ADDENDUM No. 1 TO BID DOCUMENTS FOR THE

LITTLE LAKE SHORELINE PROTECTION AND MARSH CREATION
SEGMENT 1 AND 2 DEMOLITION & PERPENDICULAR ROCK DIKE
CONSTRUCTION PROJECT BA-0037

STATE OF LOUISIANA
COASTAL PROTECTION AND RESTORATION AUTHORITY

March 2nd, 2018

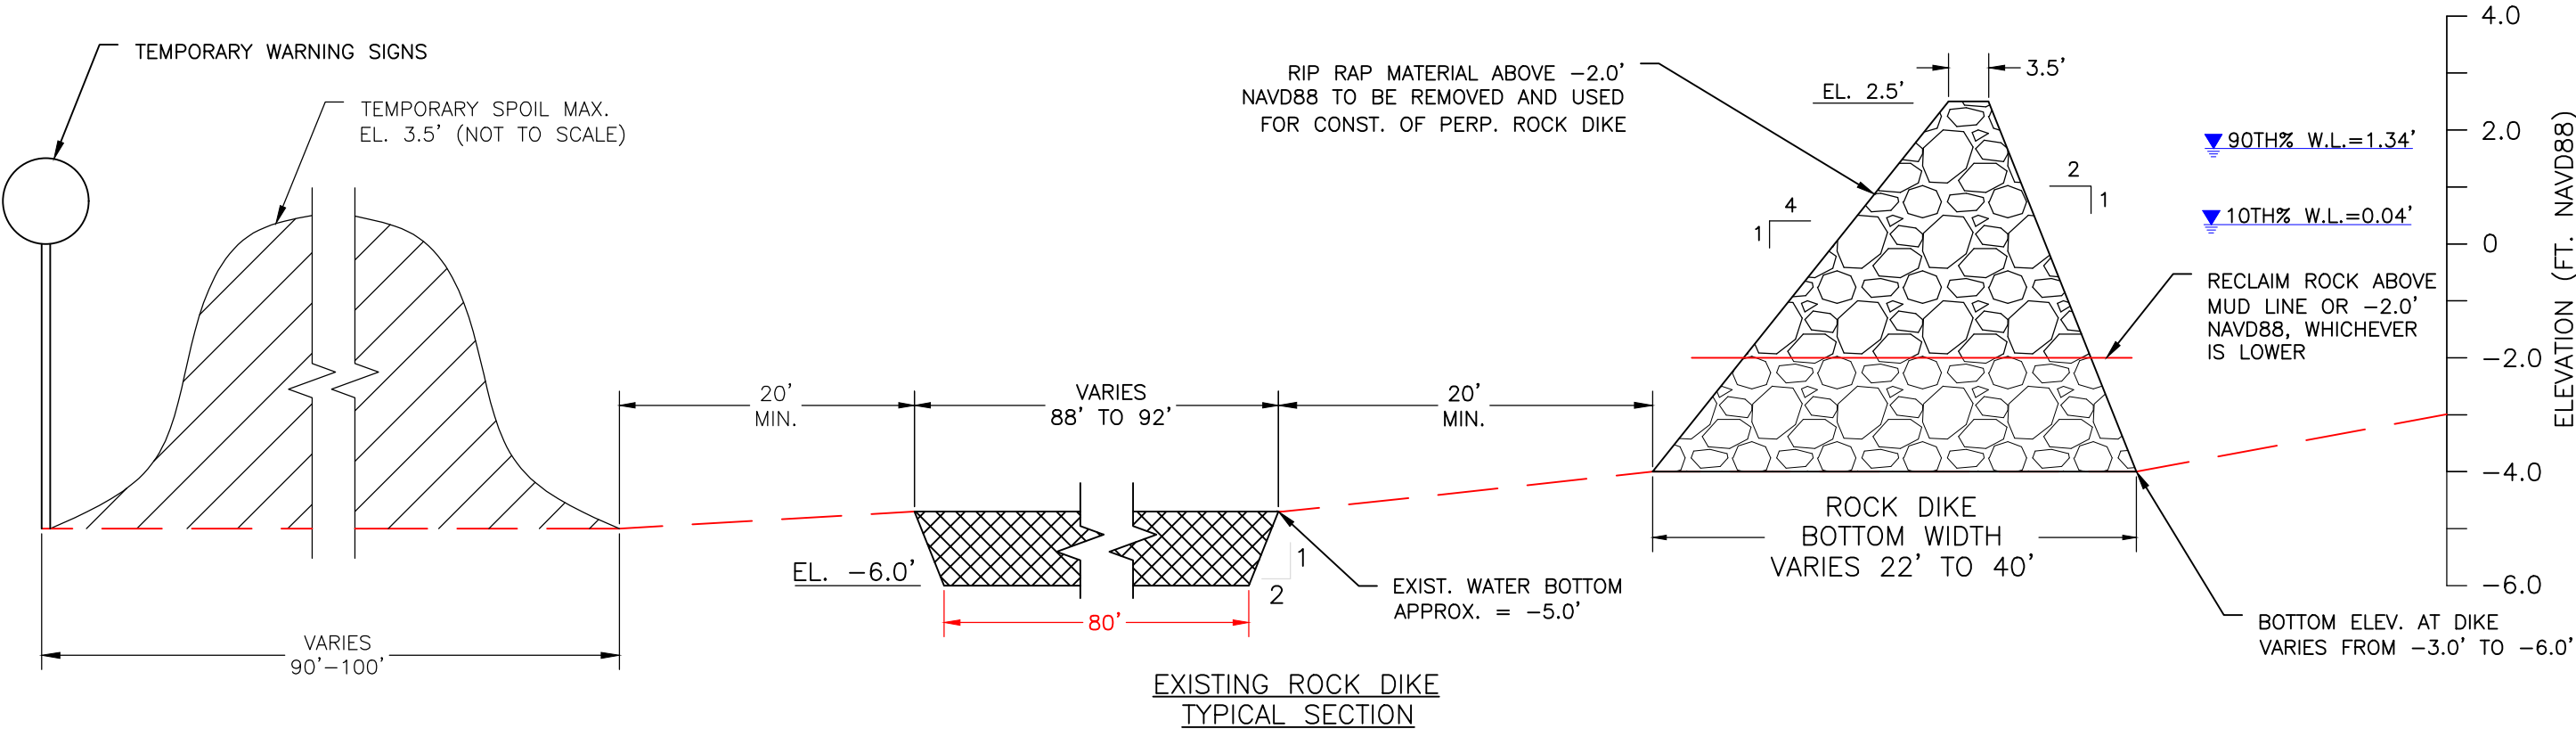
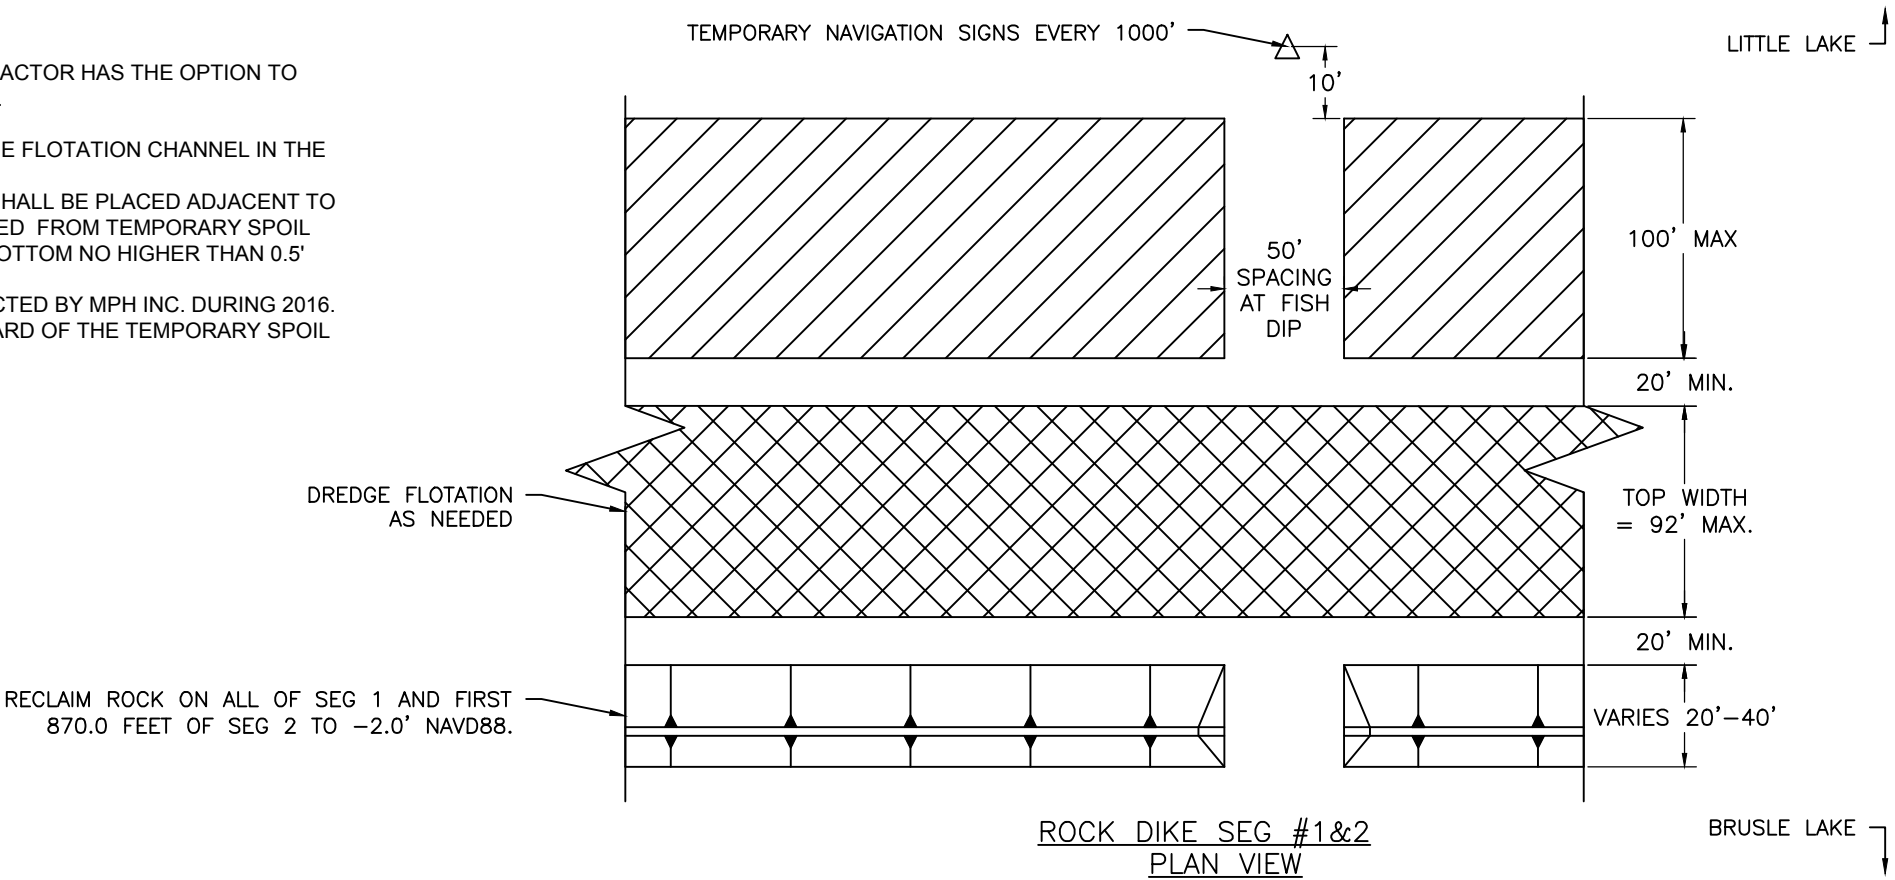
11. **Question:** What is the allowable width of the Flotation Channel?

Answer: The Contract documents have conflicting information regarding maximum allowable bottom width of flotation channels. Maximum Flotation Channel bottom width shall be 80 feet. See Attachment D of this Addendum for plan sheets reflecting the change.

A	03/02/18	CORRECTED FLOATATION CHANNEL WIDTH TO REFLECT 80 FEET AS SEEN ELSEWHERE IN PLANS	B.J.H.
REV.	DATE	DESCRIPTION	BY

1. PERMITTED FLOATATION CHANNELS ARE SHOWN. THE CONTRACTOR HAS THE OPTION TO CONSTRUCT FEWER, SMALLER, AND/OR SHORTER CHANNELS.
2. MAX FLOATATION BOTTOM WIDTH = 80'
3. THE CONTRACTOR SHALL VERIFY THE ELEVATIONS ALONG THE FLOATATION CHANNEL IN THE PRE-CONSTRUCTION SURVEY.
4. THE SPOIL FROM FLOATATION AND MAINTENANCE DREDGING SHALL BE PLACED ADJACENT TO THE CHANNEL. THE FLOATATION CHANNEL SHALL BE BACKFILLED FROM TEMPORARY SPOIL AREA PRIOR TO PROJECT COMPLETION, LEAVING THE LAKE BOTTOM NO HIGHER THAN 0.5' ABOVE PRE-CONSTRUCTION ELEVATIONS.
5. THE ELEVATIONS SHOWN ARE BASED ON A SURVEYS CONDUCTED BY MPH INC. DURING 2016.
6. TEMPORARY WARNING SIGNS SHALL BE PLACED 10.0' LAKEWARD OF THE TEMPORARY SPOIL
